INSPECTION REPORT
Sedimentation Structure
N6-E
Black Mesa Mine
Navajo County, Arizona
for
PEABODY COAL COMPANY

Dames & Moore
10139-011-22

EXISTING
MAXIMUM CROSS-SECTION
A-A'
N6-E

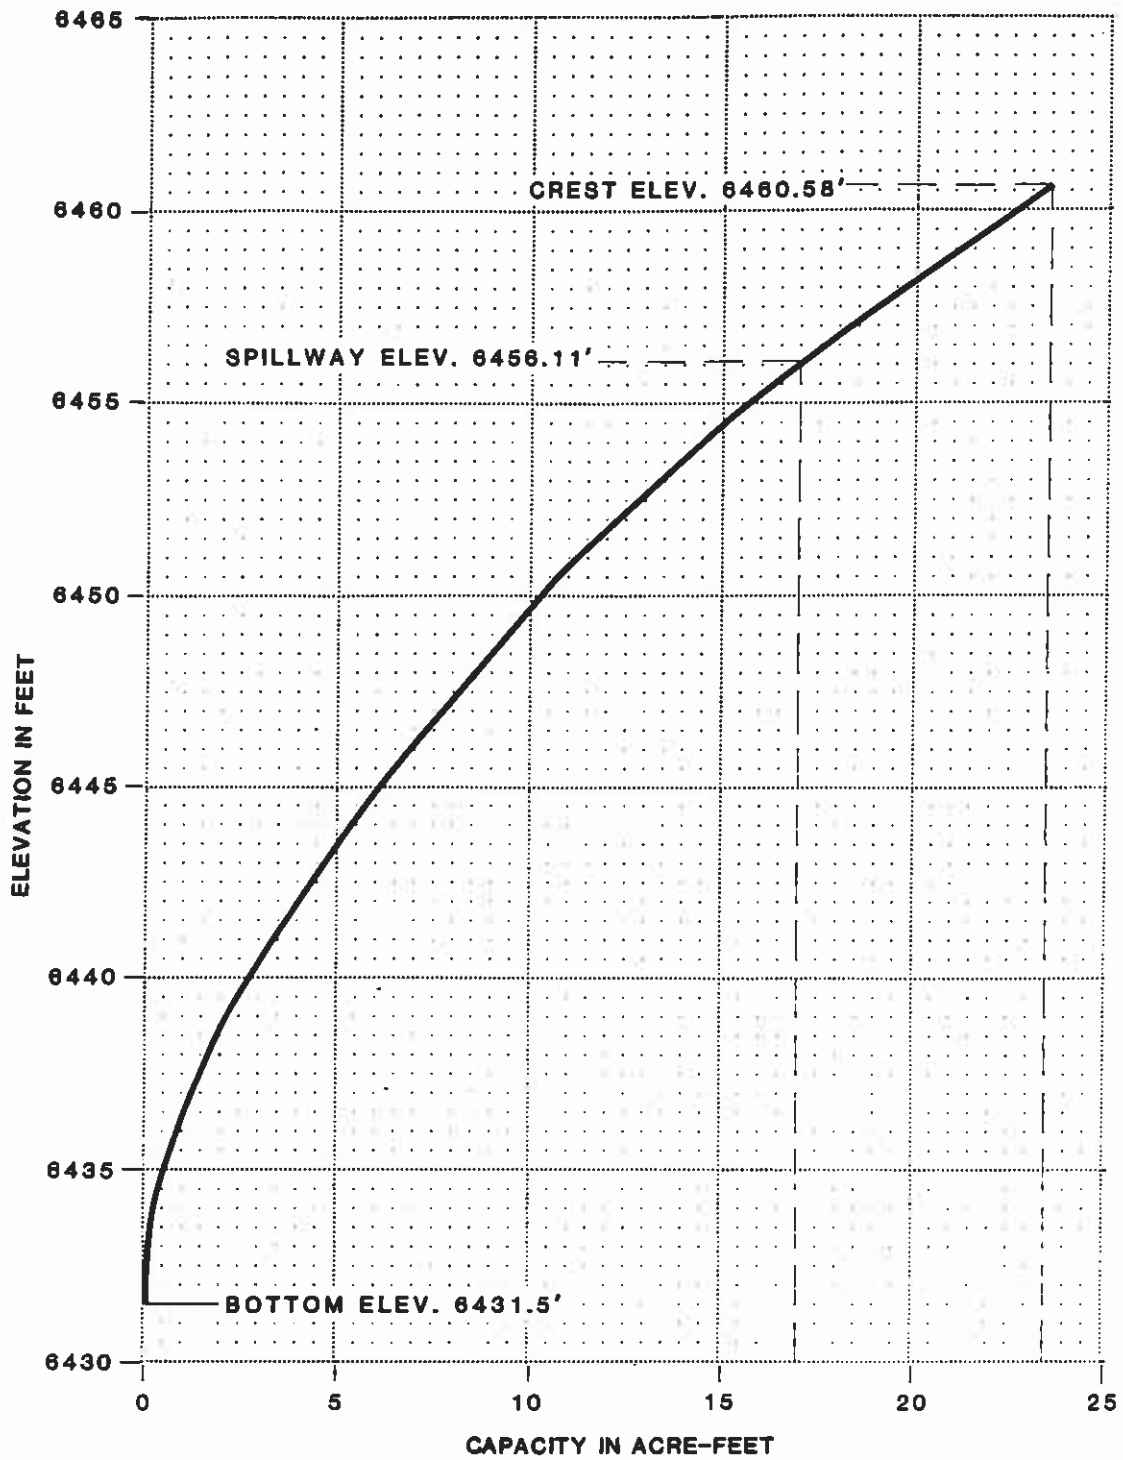
The N6-E embankment is lower in height; however, the downstream slope is steeper than the category standard; therefore, the embankment has factors of safety less than the design minimum.

The inspection of Structure N6-E indicated that the only geotechnical problem is rill and gully erosion on the upstream and downstream slopes. Correction of erosion is considered a periodic maintenance task and does not require remedial action. The downstream slope should be flattened to 3.25 horizontal to 1 vertical to meet stability requirements.

CHANNEL PROFILE B-B'
N6-E

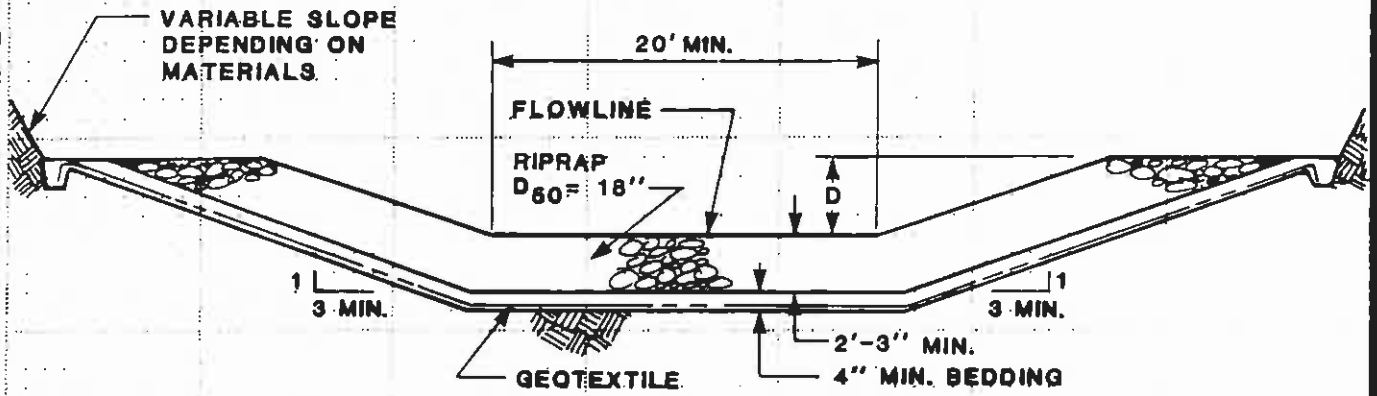
The storage capacity and spillway capacity of Structure N6-E are adequate. The outflow channel is protected with riprap but the spillway channel is only partially protected with riprap. The spillway channel should be protected against erosion using geotextile and riprap as shown in Plate 5. A stilling basin should be constructed to the dimensions shown in Plate 6 and protected against erosion using geotextile and riprap as shown in Plate 5. Plate 4 shows the profile for the existing spillway, outflow channel and proposed stilling basin.

SPILLWAY AND
OUTFLOW CHANNEL
CROSS SECTION
N6-E

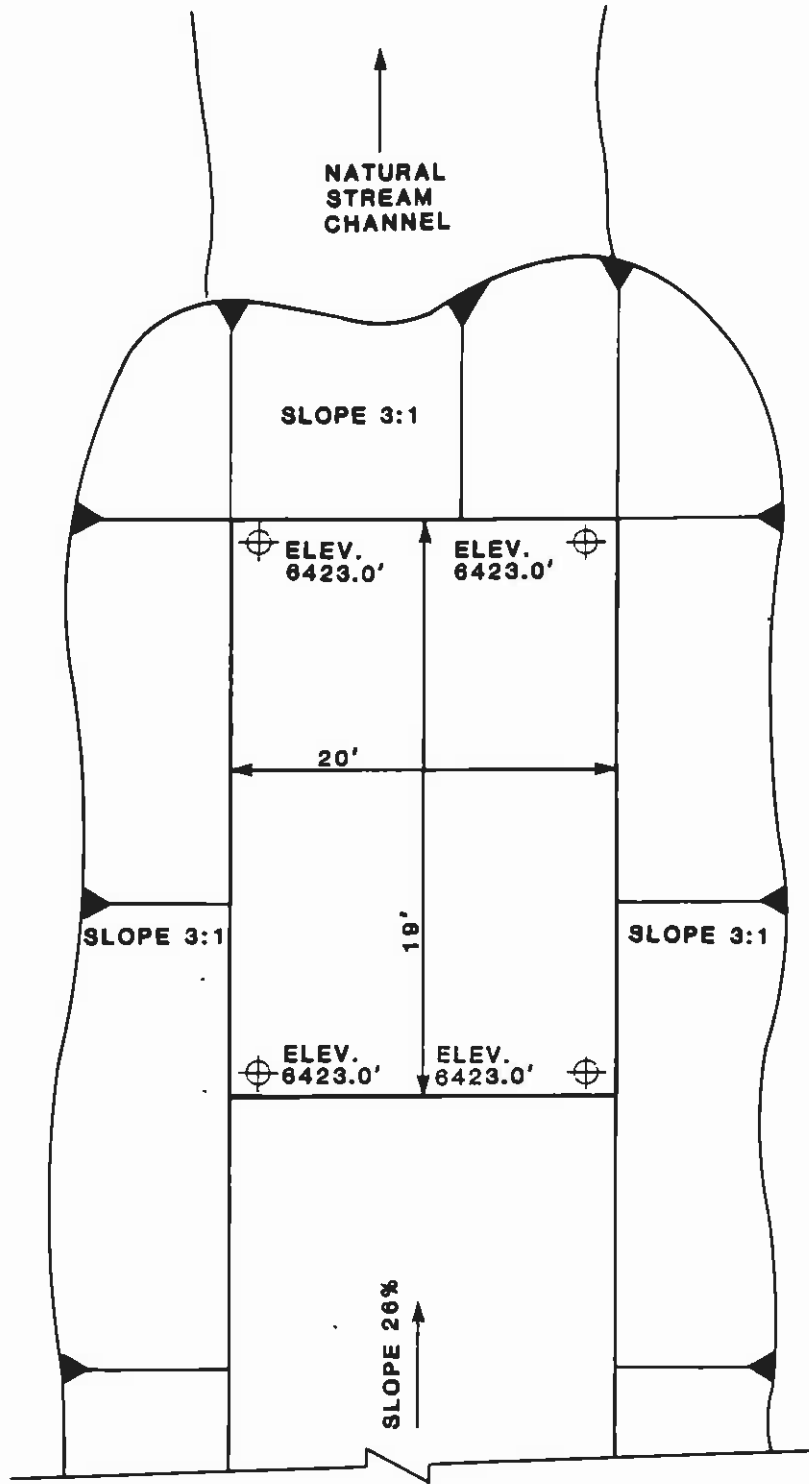
There is presently partial erosion protection within the channel.
